Access Compliance Report

Public Rights-of-Way

(Curb Ramps)

Intersection ID: 24751	Main Street: CINNAMON_FIELD_RD	Cross Street: WILD_HEATHER_CT	Location: NW
ADA ID: 83BC11A65BCD	Ramp Type: Perp	Initial Pass/Fail: Fail	Overall Compliance: No
Severity Score: 30			
Codes/Mitigation Info/Possible Solution		Field Measurements/Component Compliance

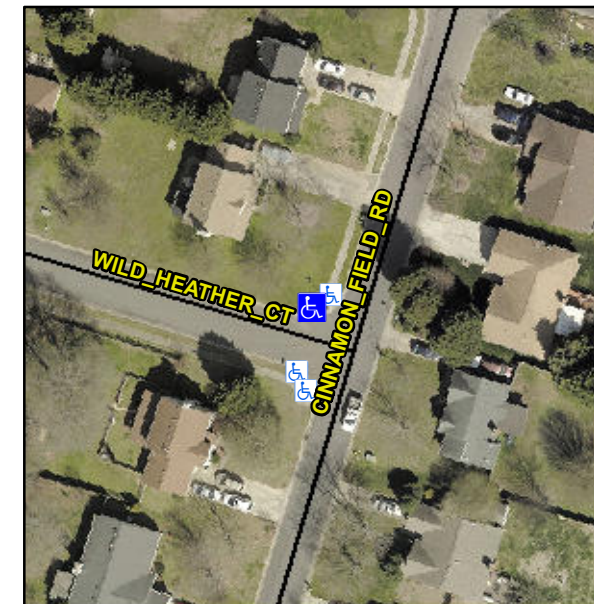
R304.5.1, R304.2.2

Compliance	Description	Data	Compliance	Description	Data
N/A	Ramp Length (in)	92.0	No	Ramp Slope (%)	8.9
No	Ramp Width (in)	32.0	Yes	Ramp XSlope (%)	1.5
N/A	Flare Type LT	N/A	N/A	Flare Type RT	N/A
N/A	Flare Slope LT (%)	N/A	N/A	Flare Slope RT (%)	N/A
N/A	Flare Traversable LT?	N/A	N/A	Flare Traversable RT?	N/A
N/A	Landing Length (in)	N/A	N/A	DWS Provided?	N/A
N/A	Landing Width (in)	N/A	N/A	DWS Contrast?	N/A
N/A	Landing Slope (%)	N/A	N/A	DWS Length (in)	N/A
N/A	Landing X Slope (%)	N/A	N/A	DWS Full Width?	N/A
N/A	Landing Curb? (Y/N)	N/A	N/A	DWS Offset (in)	N/A
N/A	Shared Landing?	N/A			
N/A	Gutter Ponding?	N/A	N/A	Gutter Slope (%)	N/A
N/A	Gutter Lip Ht (in)	N/A	N/A	Gutter X Slope (%)	N/A
N/A	Painted X Walk1?	No	N/A	Painted X Walk2?	N/A
	X Walk 1 Direction	To SW		X Walk 2 Direction	N/A
N/A	X Walk 1 Width (in)	N/A	N/A	X Walk 2 Width (in)	N/A
	X Walk 1 Slope (%)	2.2		X Walk 2 Slope (%)	N/A
	X Walk 1 X Slope (%)	0.3		X Walk 2 X Slope (%)	N/A

Remove & Replace Entire Ramp.
